**Staff Analysis of Proposed Amendment to the
Dane County Water Quality Plan,
Revising the Waunakee Urban Service Area Boundary
and Environmental Corridors**

**Proposed Amendment to the
Dane County Water Quality Plan, Revising
the Waunakee Urban Service Area
Boundary and Environmental Corridors**

Map 7 - Soil Type

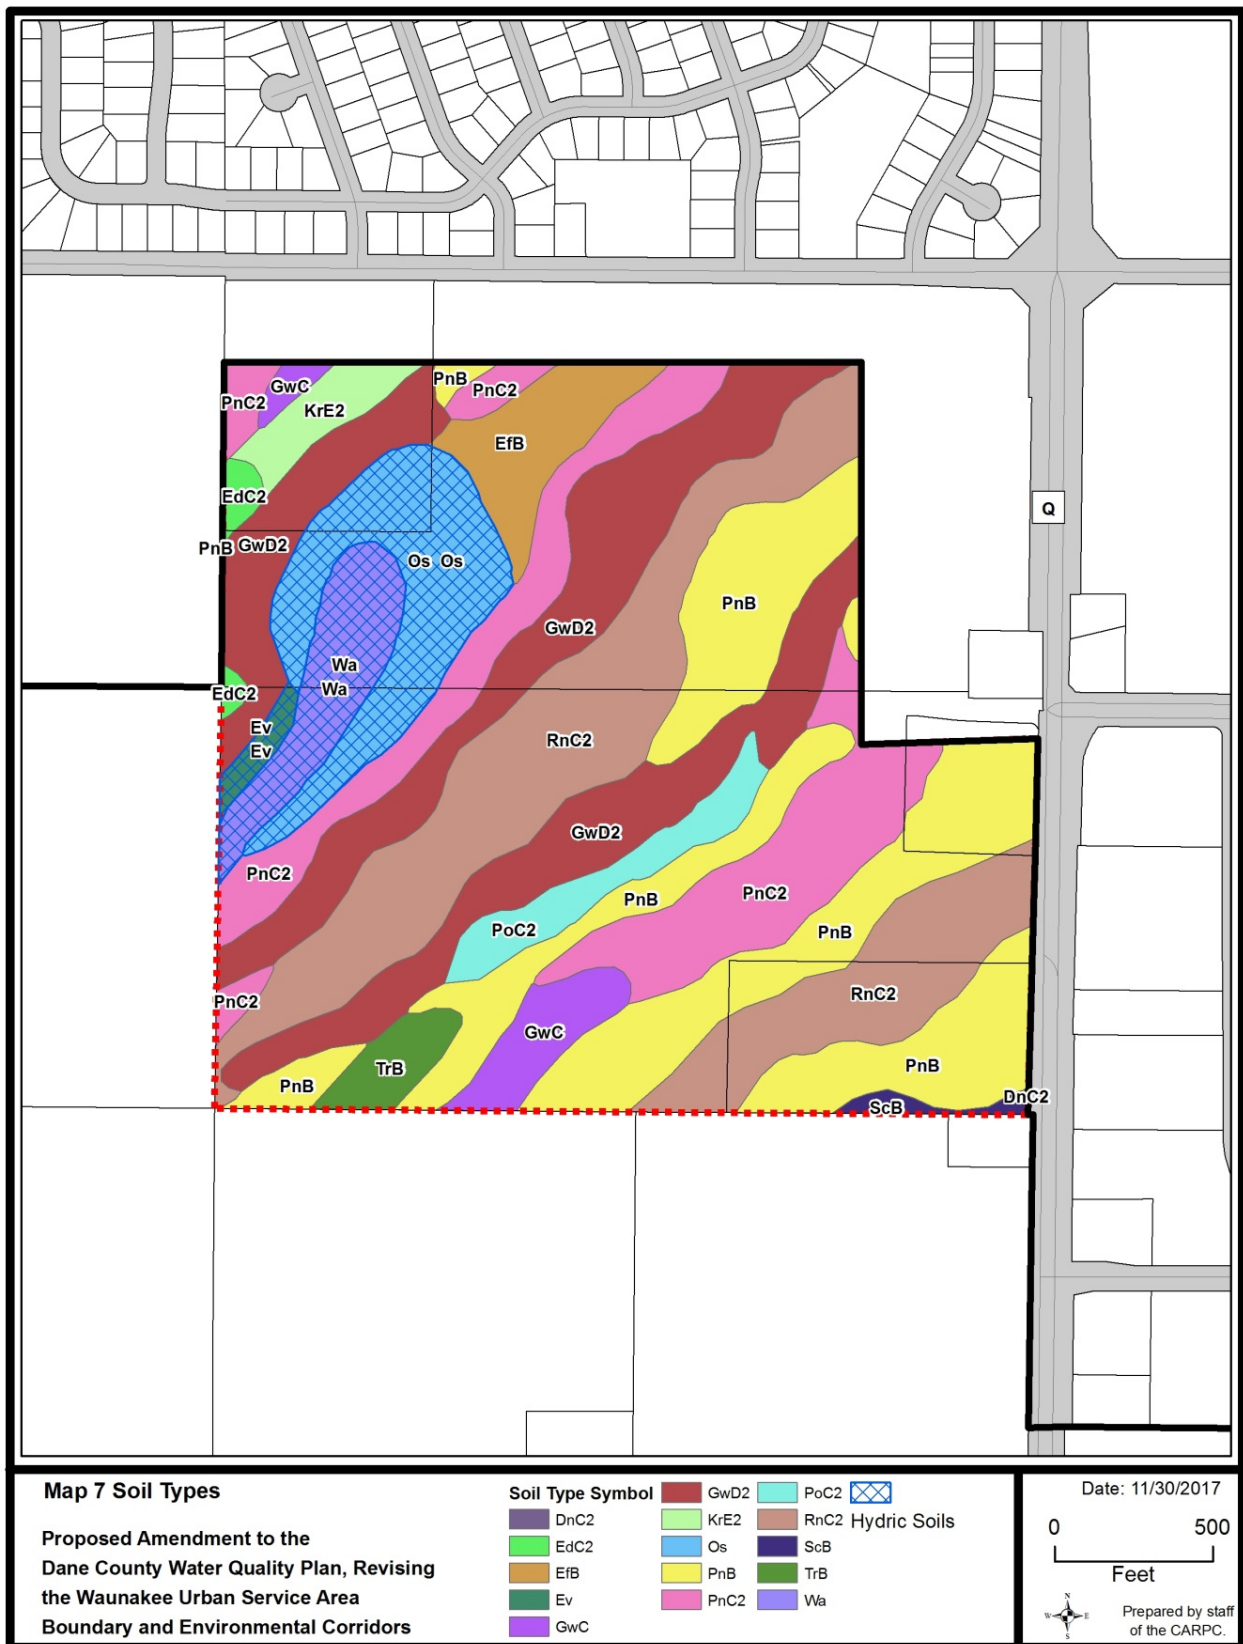
There are hydric soils (the Ev, Os, and Wa soil map units) within the amendment area (see Map 7). Their mapped location is generally consistent with, but more expansive than the mapped wetland. Hydric soils are good indicators of existing and former (drained) wetlands. Hydric soils may have the potential for wetland restoration. A wetland delineation will be required to determine the actual extents of the wetland within the proposed amendment area.

According to the [Soil Survey Geographic data for Dane County developed by the USDA Natural Resources Conservation Service](#), the Elburn, Plano, St. Charles and Troxel soils (the EfB, PnB, PnC2, ScB and TrB map units) are not hydric, but they can have a seasonal (April to June) zone of water saturation within 5 feet of the ground surface. All these soils except the Elburn (EfB) are classified as either well drained or moderately well drained. Soils with seasonal high water tables that are also classified as well drained or moderately well drained generally do not pose limitations for buildings with basements.

The Elburn soils are poorly drained and may have limited suitability for buildings with basements due to their seasonal high water table (zone of soil saturation), which can cause problems with groundwater induced flooding. These areas are well suited for park and open space areas. If these areas are developed, on-site soils investigations are recommended to determine the actual extent of seasonal high groundwater areas. Restrictions are recommended in confirmed problem areas to establish the lowest allowable level of any structure so that it is situated well above the high water table to reduce the potential for groundwater induced flooding.

4. Conduct a wetland delineation and assessment report using the Wisconsin Wetland Rapid Assessment Methodology for wetland condition and function and the Floristic Quality Assessment for plant community condition. Submit the report for Regional Planning Commission staff and DNR review.

Map 8 WGNHS Bedrock Depth and Potential Karst Features

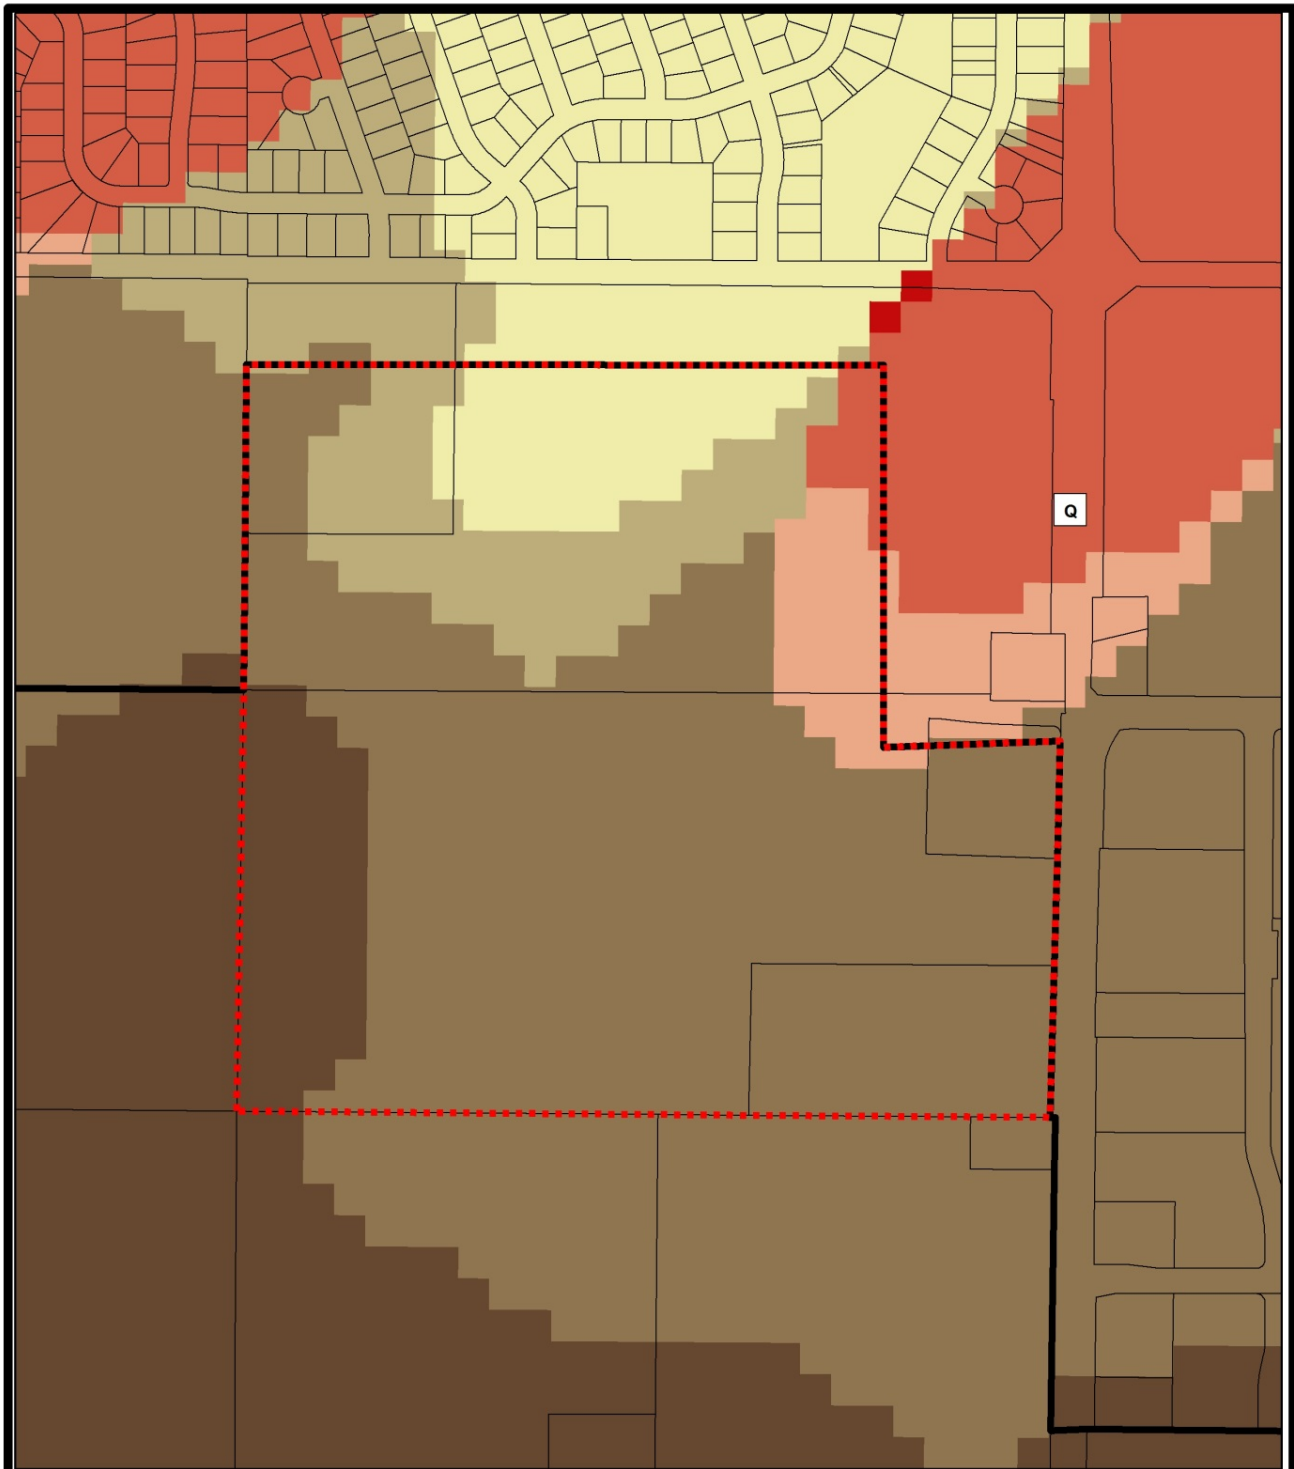
As is common throughout much of the upper Midwest, karst features such as enlarged bedrock fractures are prevalent in the local dolomite uplands. Karst features such as vertical fractures and conduits provide primary pathways for groundwater movement and can dramatically increase groundwater susceptibility when present. The location of karst features are difficult to predict, and the thickness and type of the overlying soil greatly affects how much water drains into them. Where clay soils are thick, infiltration rates are likely to be very low. However, where bedrock fractures are near the surface infiltration rates can be very high. Based on the WGNHS karst potential data, a majority of the amendment area has no potential for karst features (see Map 8). A small portion of the northeast corner of the amendment area has bedrock with potential karst units, with a depth from surface ranging from 20 to 80 feet. The DNR Conservation Practice Standard 1002 - Site Evaluation for Stormwater Infiltration requires field verification for areas of the development site considered suitable for infiltration. This includes a site assessment for karst features in this area.

2. Conduct a field verification for areas of the development site considered suitable for infiltration including a site assessment for karst features as required by the Wisconsin Department of Natural Resources Conservation Practice Standard 1002 - Site Evaluation for Stormwater Infiltration.

Map 11 – Proposed Stormwater Management System

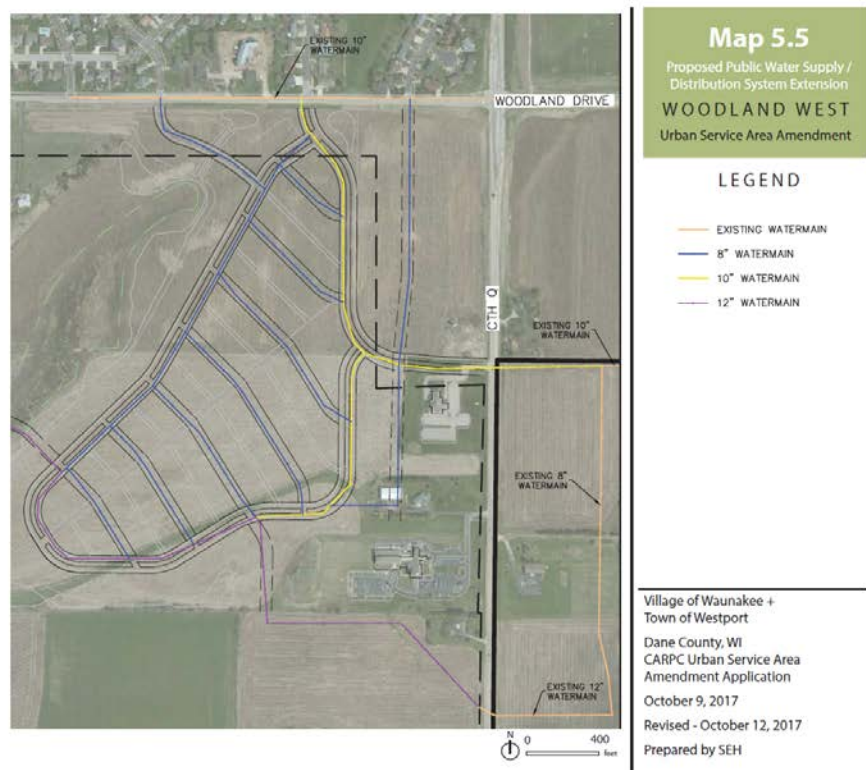
The preliminary stormwater management plan for the amendment area includes depressed boulevard road profiles with integrated bioretention along with a conventional wet pond and infiltration basin at the low point of the landscape. The swale-based road profile replaces a traditional curb-and-gutter section in a large portion of the development area and provides water quality and quantity treatment where a traditional inlet and piped conveyance system does not. These facilities will generally be strategically located to adequately provide water quality treatment and pretreatment, or 80% TSS reduction, followed by volume reduction facilities. In the joint planning area, the Village of Waunakee follows the Town of Westport stormwater ordinance which requires infiltration of 100% of the increased post-development runoff volume, when compared to the predevelopment volume, resulting from the 100-year, 24-hour design storm. It is anticipated that infiltration performance will further reduce TSS (and other pollutants such as Total Phosphorus) from stormwater discharges as well as reduce runoff temperature. While infiltrating the increased volume of runoff between the pre- and post-developed site provides more volume control than the County requirement to match 90% of the predevelopment average annual stay-on, it provides less volume control than maintaining 100% of the predevelopment average annual stay-on. Collectively, the stormwater facilities will provide peak discharge rate control to account for storms up to and including the 100-year rainfall event. The stormwater facilities will be owned and maintained by the Village of Waunakee.

A majority of the topographic low points and valleys of the amendment area have the potential to experience a seasonal high water table between three and five feet of the surface, which will require care when siting infiltration practices so as to not impact groundwater quality. The DNR Conservation Practice Standard 1002 - Site Evaluation for Stormwater Infiltration requires field verification for areas of the development site considered suitable for infiltration. This includes a site assessment for karst features on the site to locate infiltration facilities appropriately so that performance can be maximized while

protecting groundwater resources. The Village's plan to incorporate bioretention higher in the landscape is advantageous should limiting conditions be found at the proposed stormwater management facilities locations along the south edge of the site.

1. Submit a detailed stormwater management plan for Regional Planning Commission staff review and approval (in conjunction with DCL&WCD staff) prior to any land disturbing activities in the amendment area. The stormwater management plan shall include the following:
 - a. Install stormwater and erosion control practices prior to other land disturbing activities. Protect infiltration practices from compaction and sedimentation during land disturbing activities.
 - b. Control peak rates of runoff for the 1-, 2-, 10-, and 100-year 24-hour design storms to pre-development levels, in accordance with the Dane County Stormwater Ordinance.

3. Stormwater management facilities shall be placed in public outlots whenever feasible and designated as environmental corridor. Easements and perpetual legal maintenance agreements with the Village, to allow the Village to maintain stormwater management facilities if owners fail to do so, shall be provided for any facilities located on private property.

Map 12 – Municipal Wells and Modeled Baseflow Locations

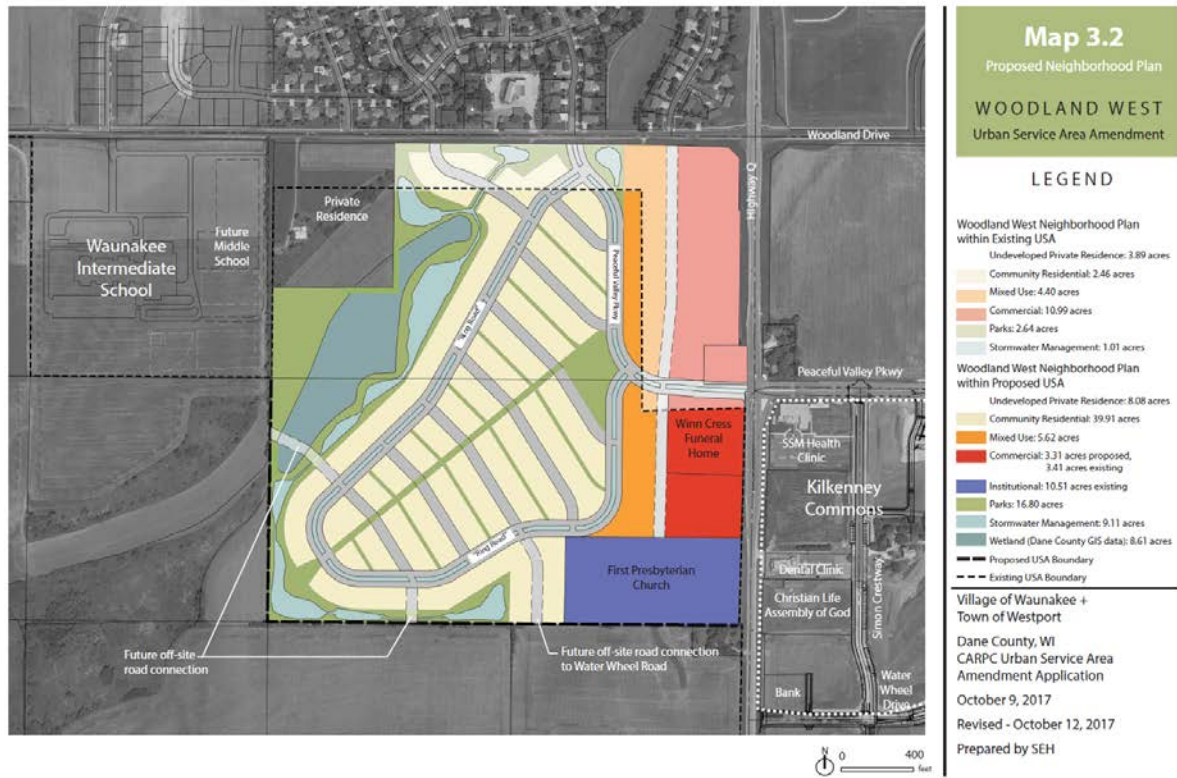
Groundwater modeling indicates that the cumulative effects of year 2010 well water withdrawals from all municipalities have resulted in a 2 cfs decline in baseflow in Sixmile Creek (see Map 12 and Table 4) compared to the pre-development (no pumping) baseflow of 13.3 cfs. An additional 0.7 cfs decline is anticipated by the year 2040, according to modeling, reducing the baseflow to 10.6 cfs. According to the 2014 DNR report [*Ecological Limits of Hydrologic Alteration in Dane County Streams*](#), no significant change in the fish community status from 2010 conditions is expected to occur as a result of the projected 2040 reduction in baseflow in Sixmile Creek.

5. Develop and implement a water loss control plan as required by PSC 185.85(4)(b)
6. Work with Regional Planning Commission staff to develop a long term water supply plan for the Village using the regional groundwater model.
